8.1 **DA 2016/744 - 64 Allens Parade, Lennox Head.DOC**

REFERENCE DA 2016/744 LOT 61
DP29654.
64 ALLENS PARADE.
LENNOX HEADS. 2478.

Application for extension of closing date on DA 2016/744.

Drawing Title
**Driveway
Cross Sections**

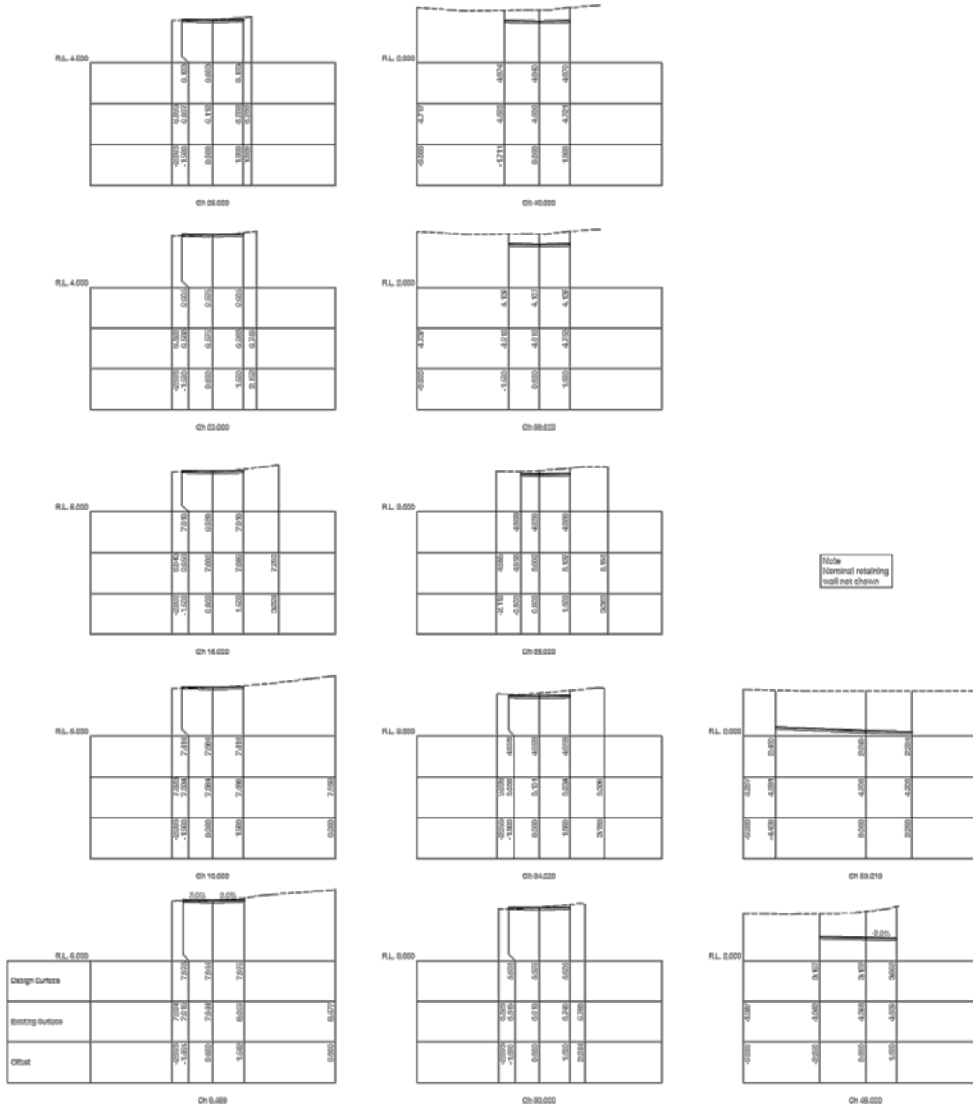
Thanks for your response. Unfortunately the driveway cross section does not include the critical cross-section at the intersection of the sewer line. It is a physical issue as the whether there is a clash – and if so how the design is modified to accommodate the sewer line.

Figure 1. Indicative site plan showing trees in relation to the proposed development.

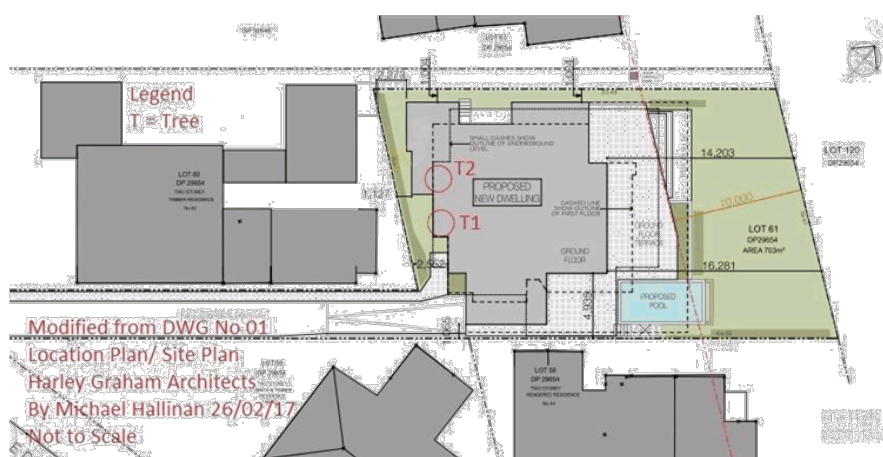
Figure 1 shows that the proposed development construction and excavation would occur in the areas occupied by the tree trunks and roots. The proposed development would therefore physically displace the two trees making it impossible to retain the trees and necessitating tree removal.

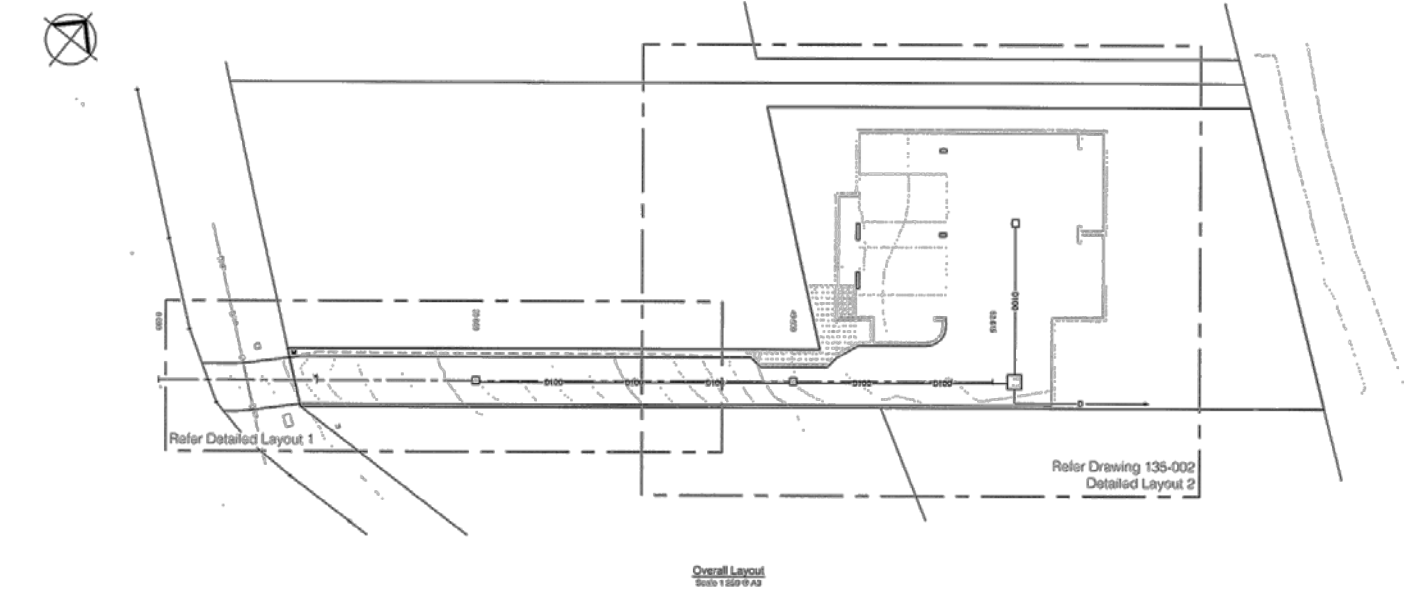
The "*Cross Section of the Driveway & Stormwater Plans for Public Access*" was posted on the BSC DA website on 24 January 2017. The enclosed building envelope plan, according to the scale 1:200, shows that the 1.8m height and 45deg envelope aspect, as depicted by the red dotted line on the western, northern and southern elevation of the proposed building, are calculated from the **ground floor finished surface level**.

The 1.8m height should be measured from **ANGL (above natural ground level)**. This is a difference of 450mm. This significantly alters and lowers the level at which the 45deg envelope angle intersects the proposed building as shown on the plan.

This distortion of the building envelope plan gives an erroneous impression of the extent of the encroachments outside the allowable envelope as set out in the BSCDCP.
